Paper Calendar - ESP32-S3 e-paper board (PhotoPainter drop-in)

1. Cover

Customer	alsoft (own board)
Board	Paper Calendar - ESP32-S3 e-paper board (PhotoPainter drop-in)
Revision	0.1
Date	2026-11-01
Reviewer	alsoft

M01 close-up

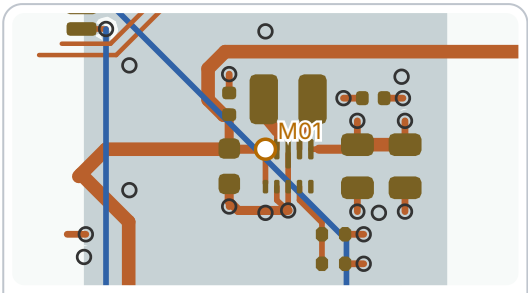
M01 decoupling_order

medium · U3.10, C7, C6

U3 pin 10 (VSYS): the small 100 nF capacitor C7 is 2.2 mm away while the larger 10 µF C6 is closer at 1.6 mm, so the small one is not nearest the pin. Fix: swap them.

M02 close-up

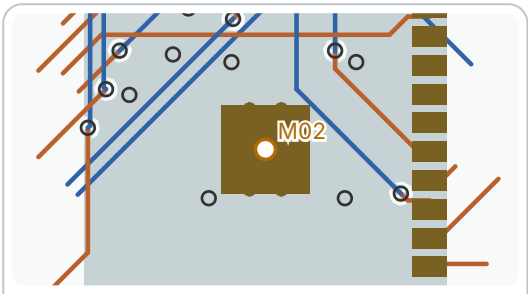
M02 exposed_pad_vias

medium · U5.41

U5: the 3.9 x 3.9 mm exposed pad has 10 vias where 11 are recommended for heat and ground. Fix: add a via grid inside the pad.

M03 close-up

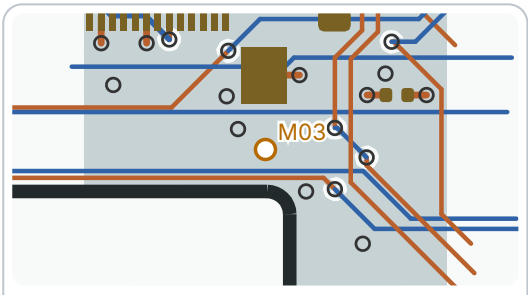
M03 edge_clearance

medium · J2

J2: the part sits 1.85 mm from the board edge but assembly needs 2.5 mm. Fix: move it inward, or order with edge rails at extra cost.

M04 close-up

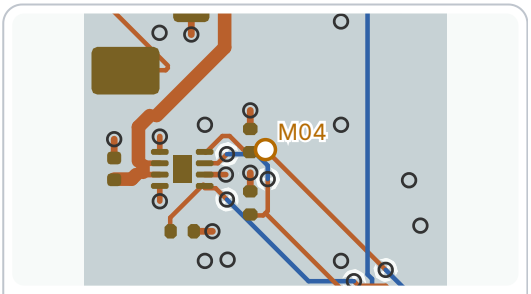
M04 acute_angles

medium · I2C_SDA

I2C_SDA: a track corner on F.Cu is sharper than recommended (tracks meet at 45 degrees), which can cause etching defects. Fix: re-route with gentler turns.

M05 close-up

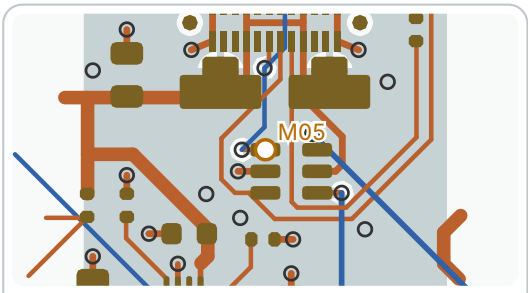
M05 esd_order

medium · J1.A7, J1.B7, U1.1, USB_C_DN

USB_C_DN: the protection part U1 sits 2 via(s) away from connector pin J1 pin A7, so surges can reach the chip first. Fix: place it right behind the connector pad on the same layer. The same issue appears at 1 more place.

M01: decoupling_order —

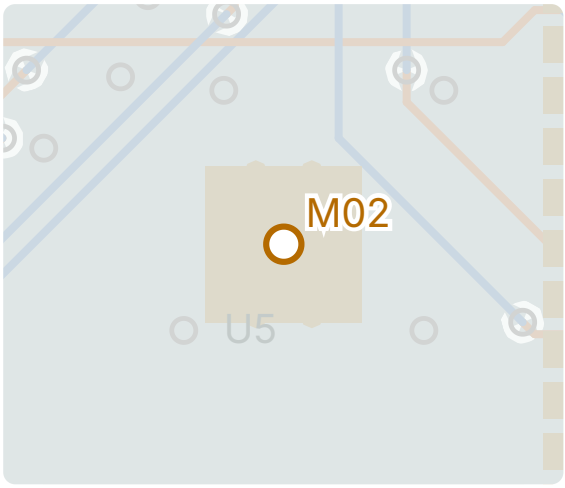
M01 — decoupling_order

Where: U3.10, C7, C6

Why: affected location (100n) is 2.2 mm from affected location [VSYS], affected location (10u) 1.6 mm

Recommendation: swap the capacitors' places, or move the small one next to the pin

M02: exposed_pad_vias —

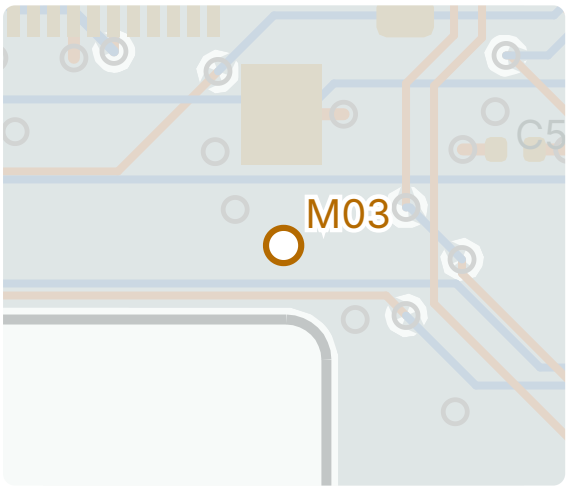
M02 — exposed_pad_vias

Where: U5.41

Why: U5 exposed pad 3.9 x 3.9 mm (15.21 mm^2) has 10 vias, 11 recommended

Recommendation: a via grid in the pad (fanout_planes exposed_in_pad=True; JLC_VIA_SMALL fits a 2x2 grid in small pads)

M03: edge_clearance —

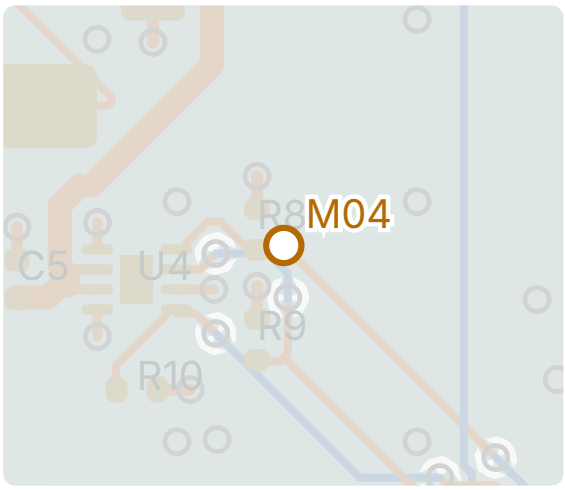
M03 — edge_clearance

Where: J2

Why: Assembled parts are inside the required assembly edge margin; per-location distances and limits are in the appendix.

Recommendation: move the part in, or order with edge rails (>= 5 mm; JLC adds them by default and charges for the panel)

M04: acute_angles —

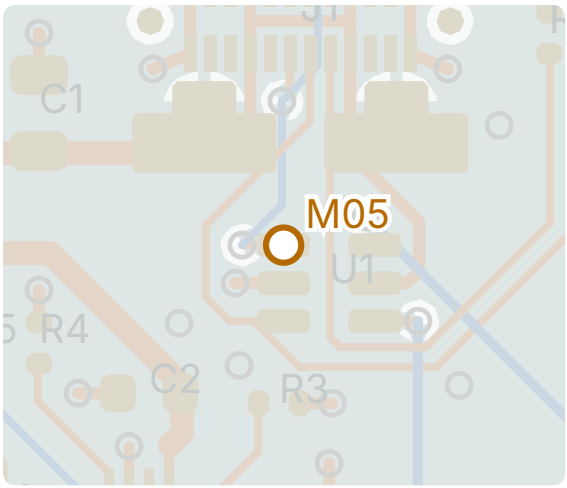
M04 — acute_angles

Where: I2C_SDA

Why: affected location on F.Cu: tracks meet at 45 degrees

Recommendation: re-route the corner with 45 degree turns, or open it up so the tracks meet at 90 degrees or more

M05: esd_order —

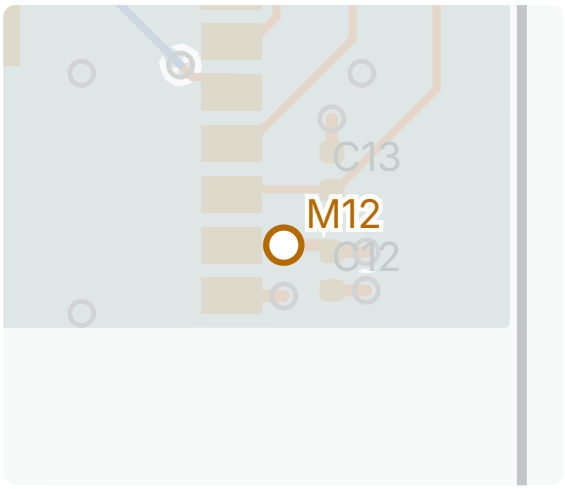
M05 — esd_order

Where: J1.A7, J1.B7, U1.1, USB_C_DN

Why: affected location: 2 via(s) between affected location and the protection part affected location

Recommendation: put the protection part on the signal path right behind the connector pad, connected on one layer, and route on from it to the IC

M12: current_width —

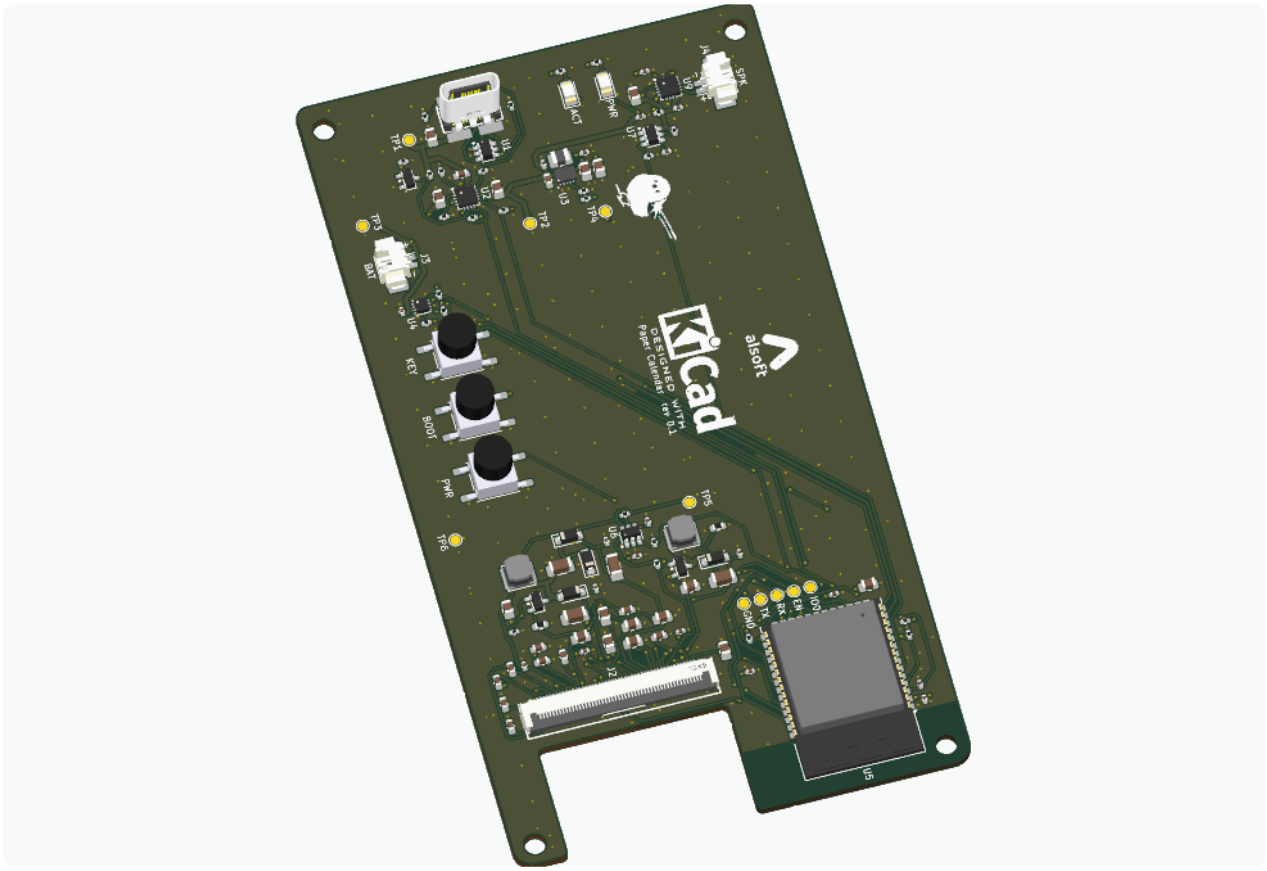
M12 — current_width

Where: 3V3

Why: track (see appendix) on F.Cu: 0.300 mm for 0.700000 A; conservative chart requires 0.502 mm at 10.0 C rise (0.0350 mm copper); not a qualified short pad neck

Recommendation: Correct the copper or intent; document any exception with a current-stage waiver and reason
